OREGON STATE UNIVERSITY
Radiation Center A100 Corvallis, Oregon 97331 - 5903
Telephone 503 - 737 - 2341 Fax 503 - 737 - 0480

Reference: Oregon State University TRIGA Reactor (OSTR),
Docket No. 50-243, License No. R-106

Subject: Request for Amendment of OSTR Technical Specifications

Replace the organization chart in specification 6.1.b with the following:

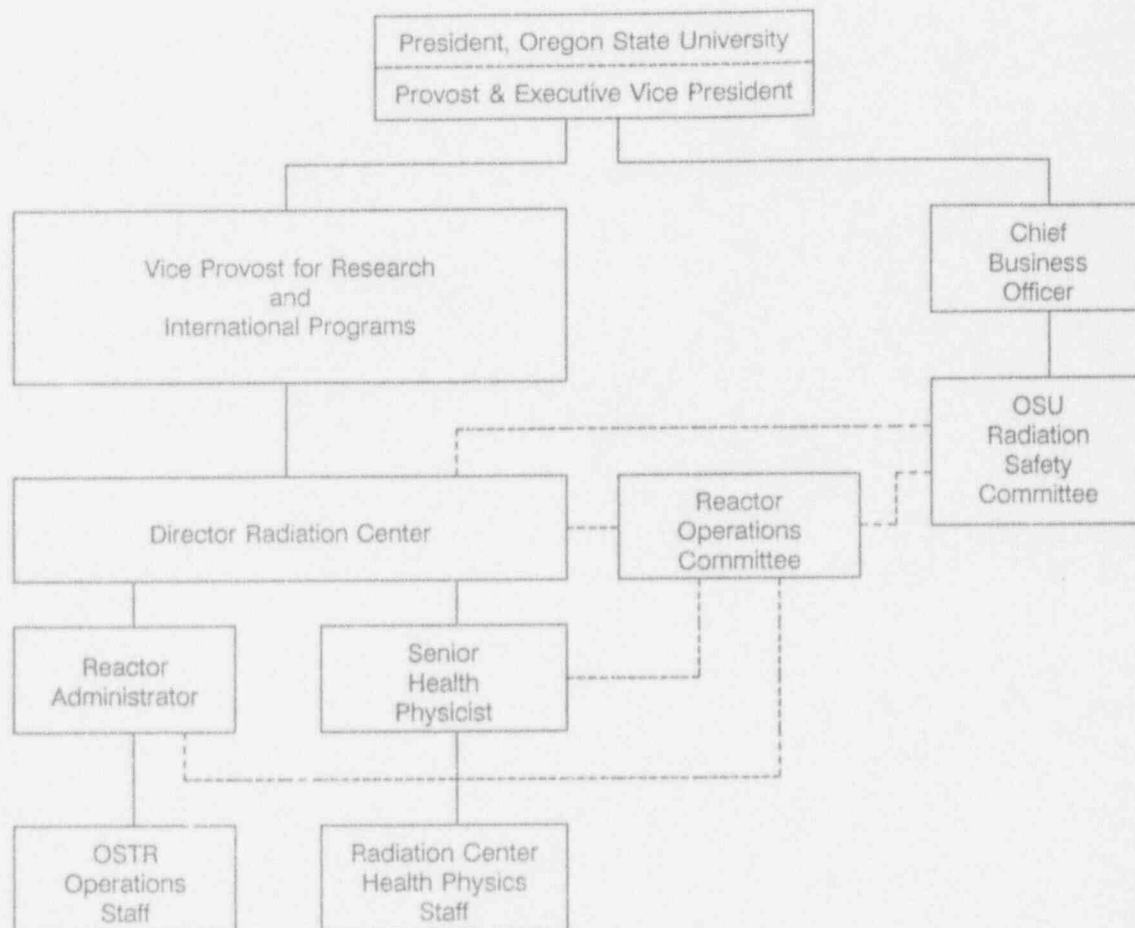
As a result of an independent review of the university's organization, a number of changes have been made to OSU's administrative structure. The position of Vice President for Finance and Administration has been renamed Chief Business Officer, and the Radiation Center Director, along with the Directors of other similar centers, now reports to the Vice Provost for Research and International Programs. The Provost, who will also serve as Executive Vice President of the university, has taken over a number of duties formerly executed by the President. Therefore, the reporting level of the Radiation Center Director has really not changed.
